*AS Constructed*  
~~HIGHWAY CONSTRUCTION BID PLANS OF PROPOSED~~  
FEDERAL AID PROJECT NO. NH 2852-014  
U.S. HIGHWAY 285  
CHAFFEE COUNTY  
CONSTRUCTION PROJECT CODE NO. 13998

AS CONSTRUCTED INFORMATION  
CONTRACTOR D.G. HUSKINS  
Project ENGINEER LARRY CISNEROS  
(Project or Resident)  
PROJECT STARTED April 21, 2003  
PROJECT COMPLETED July 17, 2003  
AS CONSTRUCTED PLANS  
APPROVED Billy Beal  
FINAL ENGINEER 9/3/03  
TITLE DATE  
J.J.S./REGION 5

Computer File Information				Sheet Revisions				As Constructed				Title Sheet				Project No./Code	
Creation Date:	16 OCT 02	Initials:	KEM	(R-1)	2/18/03	Revised Sheets 1,2,5,6,36	KEM	No Revisions:								NH 2852-014	13998
Last Modification Date:	18 FEB 03	Initials:	KEM	(R-1)	2/18/03	Deleted Sheet 30	KEM	Revised:	July 17, 2003	Designer:	WILCOXON	Structure Numbers					
Full Path:	C:\13998\			(R-X)				Void:		Detailer:	MAGOWAN	Sheet Subset:		Subset Sheets:		Sheet Number	1
Drawing File Name:	title sheet.DWG			(R-X)													
Acad Ver.	R2002	Scale:	AS SHOWN	Units:	FEET	(R-X)

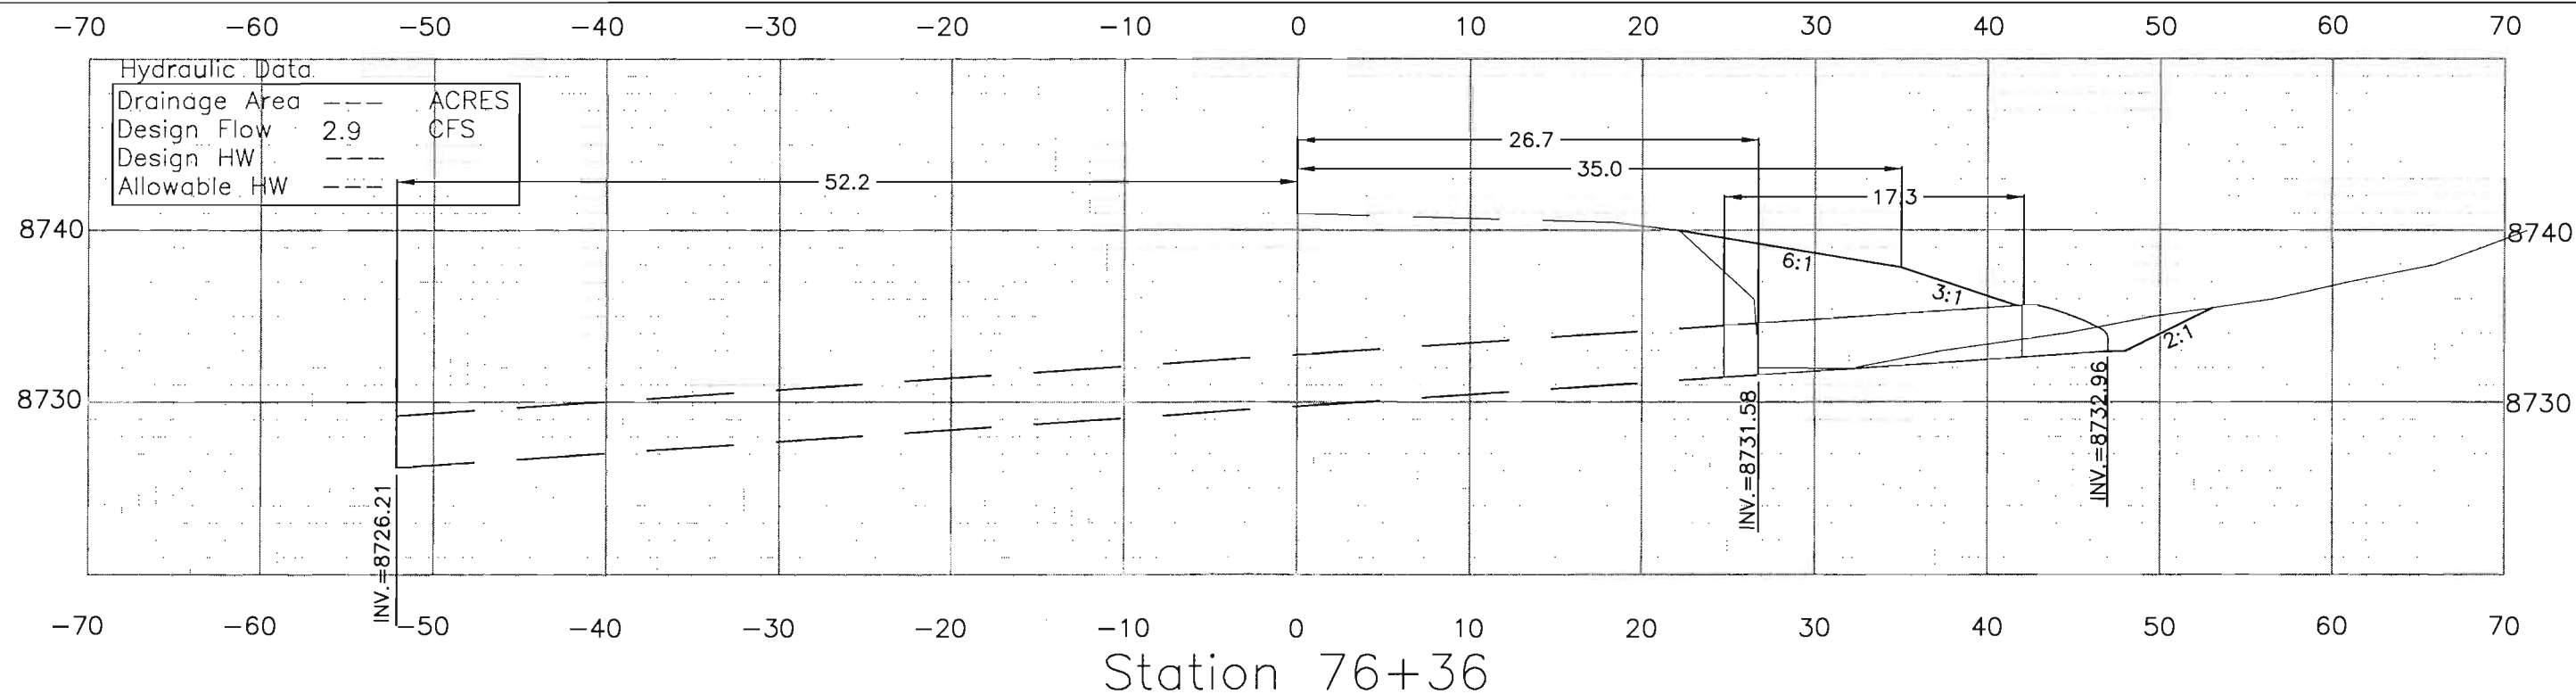
Sta. 76+36 36"x78.9' CMP  
Req'd Remove Headwall Rt. *Inlet*  
~~Req'd Remove 2' CMP Rt.~~  
Req'd Extend 17.3' Rt *16'*  
Req'd Steel End Section Rt.

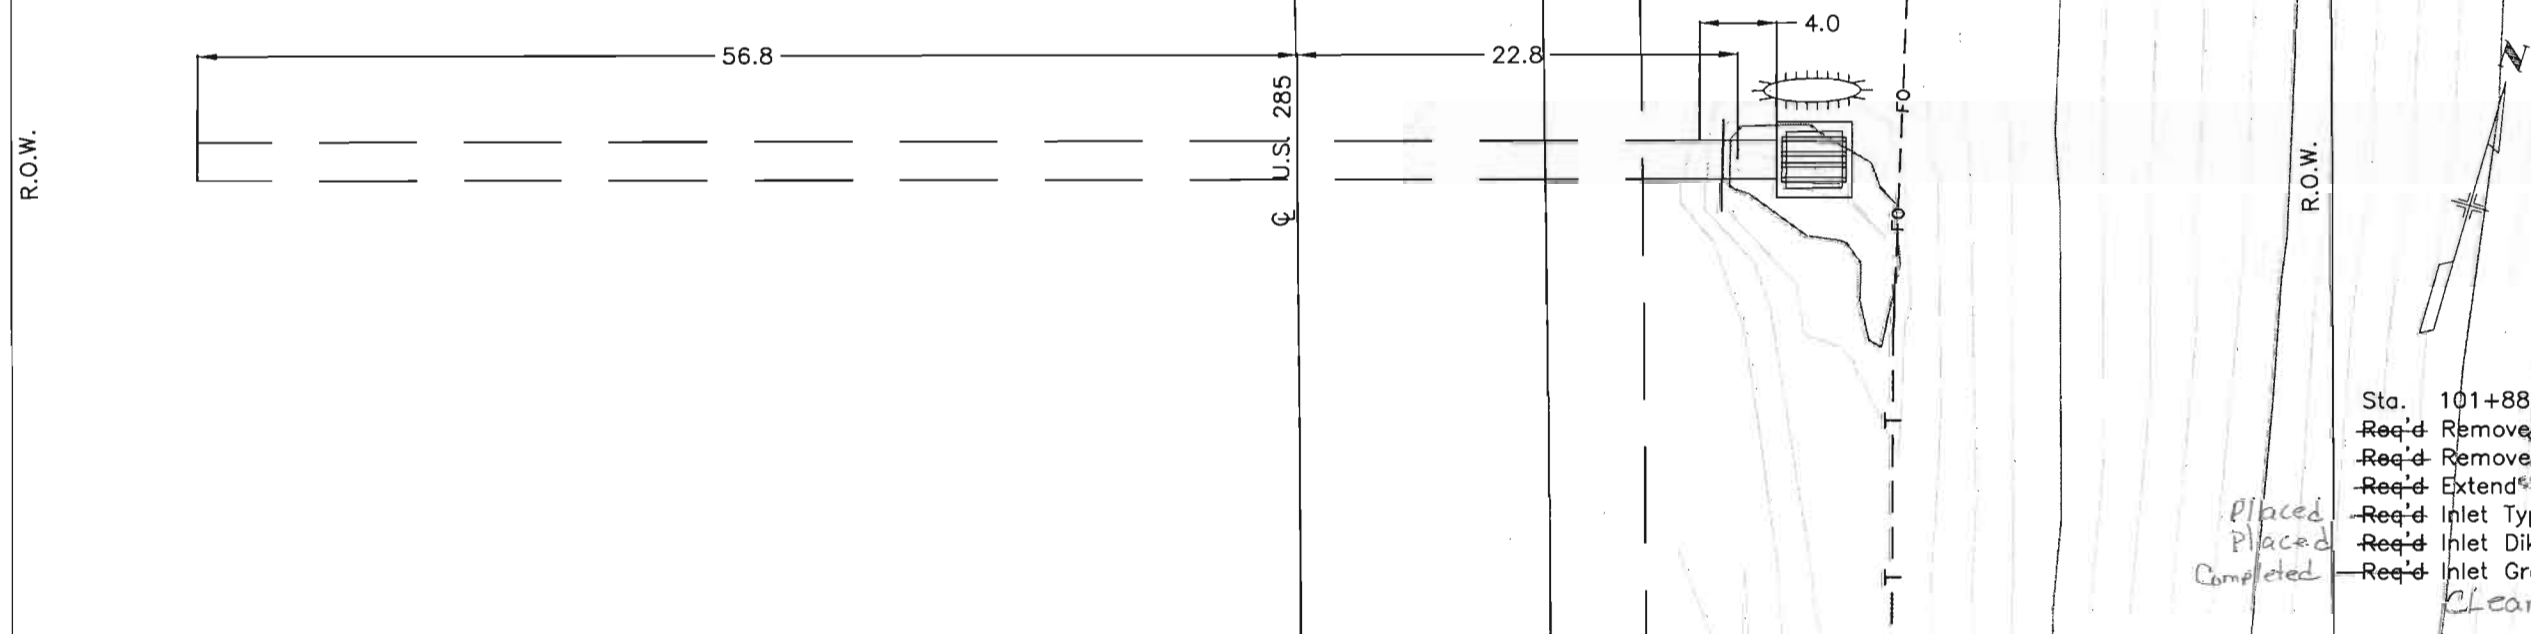
- Sta. 101+88 24"X79.6' CMP
- Req'd Remove Headwall Rt.
- Req'd Remove 2' Rt.
- Req'd Extend 4' Rt. 2.5 RT
- Req'd Inlet Type C (3ft) Rt.
- Req'd Inlet Dike Rt.
- Req'd Inlet Grading Rt.
- Cleaned Culvert

## UNDERDRAIN LOCATIONS

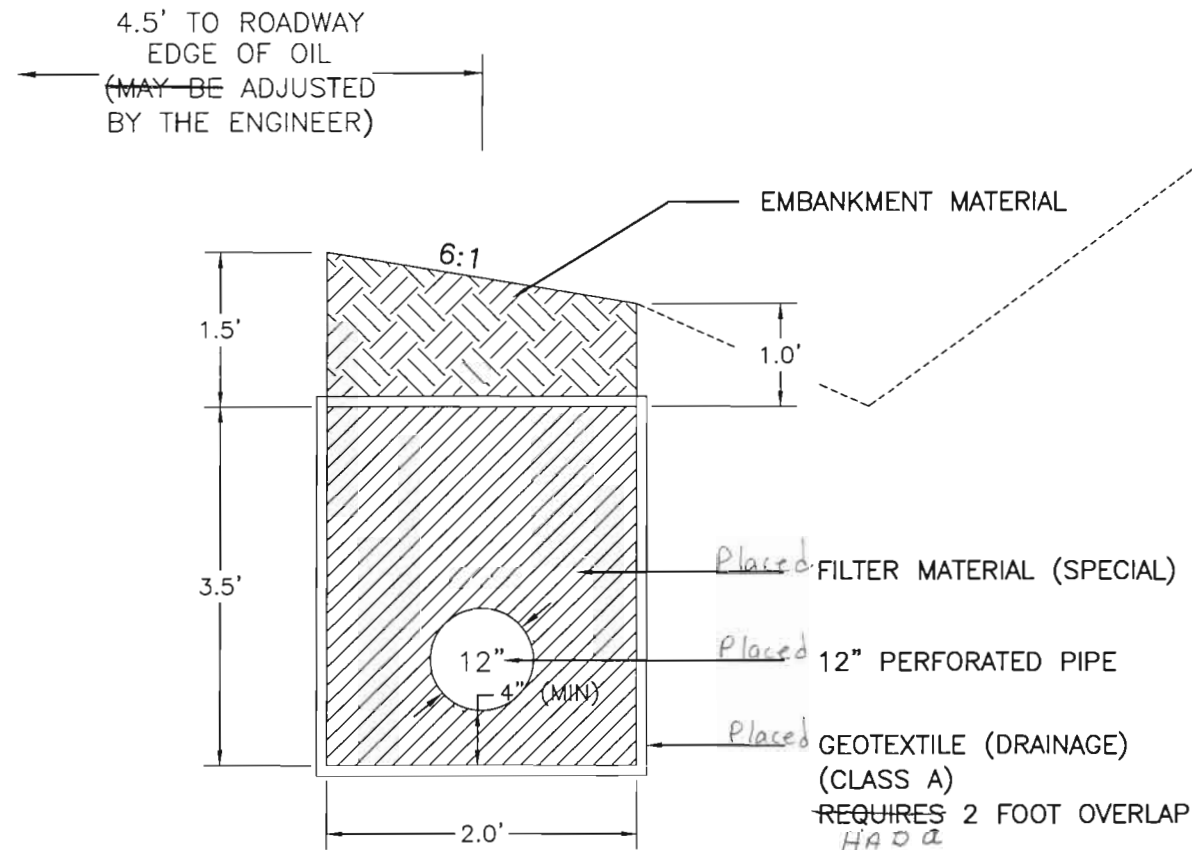
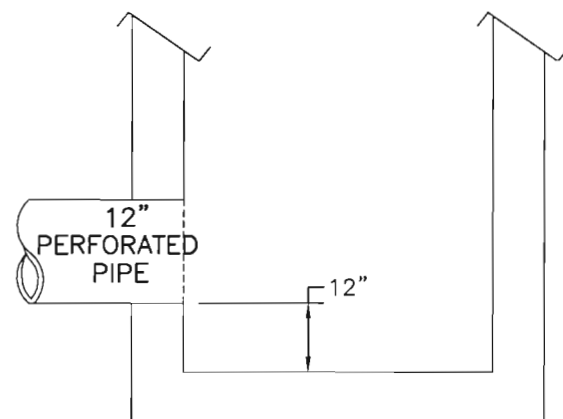
STA. 60+20 to 61+40 RT  
REQ'D 12"X120' PERFORATED PIPE  
INVERT ELEV. 8819.48 to 8814.30, -4.32% GRADE  
~~REQ'D CONNECT TO TYPE C INLET~~  
(SEE DETAIL)

placed STA 65+70 to 69+35 RT  
placed REQ'D 12"X365' PERFORATED PIPE  
ELEV 8791.30 to 8773.53, -5.53% GRADE  
REQ'D CONNECT TO TYPE C INLET  
(SEE DETAIL)
